### PLANNING COMMISSION STAFF REPORT

SUBJECT: RIOFINE NEON SIGN COMPANY ON BEHALF OF C.H.I.C. LLC REQUESTING AN APPEAL OF THE PLANNING DIRECTOR'S DECISION TO DENY A SIGN PERMIT APPLICATION FOR THE VILLAGE PUB AT 266 SOUTH PALM CANYON DRIVE (CASE 15-071

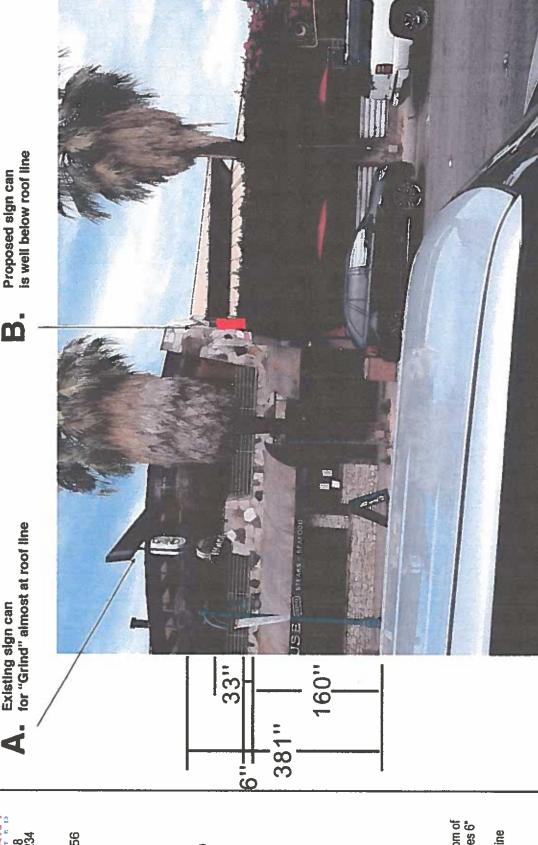
In justification for the appeal, there seems to be some discrepancy regarding the interpretation of zoning code section 93.20.09(A)(3) which states that the top of any sign shall not be higher than the building on which it is located. Please see the attached drawing 1 sating the total building height is 381" with the proposed sign for Village Pub coming in at 182" below that roof line and showing the new Grind permitted sign almost at the roof line.

This letter is to notify you that the sign permit application for the Village Pub (266 S. Palm Canyon Drive) has been denied. The application has been denied because the sign does not comply with Palm Springs Zoning Code Section 93.20.09(A)(3), which states that the top of any sign shall not be higher than the building on which it is located.

Based upon the submitted drawings, the proposed sign extends above the eave line of the portion of the building on which it is located. While it is agreed that the sign does not extend above the highest point of the roof, the intent of the code is that signs be attached to and integrated with the façade of the building, and that they not extend above the eave or cornice line of the building.

SECTION 1. The sign permit application that is the subject of this appeal shall be approved, as the proposed sign conforms to the height limitations contained in PSZC Section 93.20.09(A)(3), in that the sign does not extend above the ridgeline of the roof.

SECTION 2. The proposed sign shall otherwise conform to all requirements listed in PSZC Section 93.20.09, including area restrictions, dimensional restrictions, and all other applicable requirements.
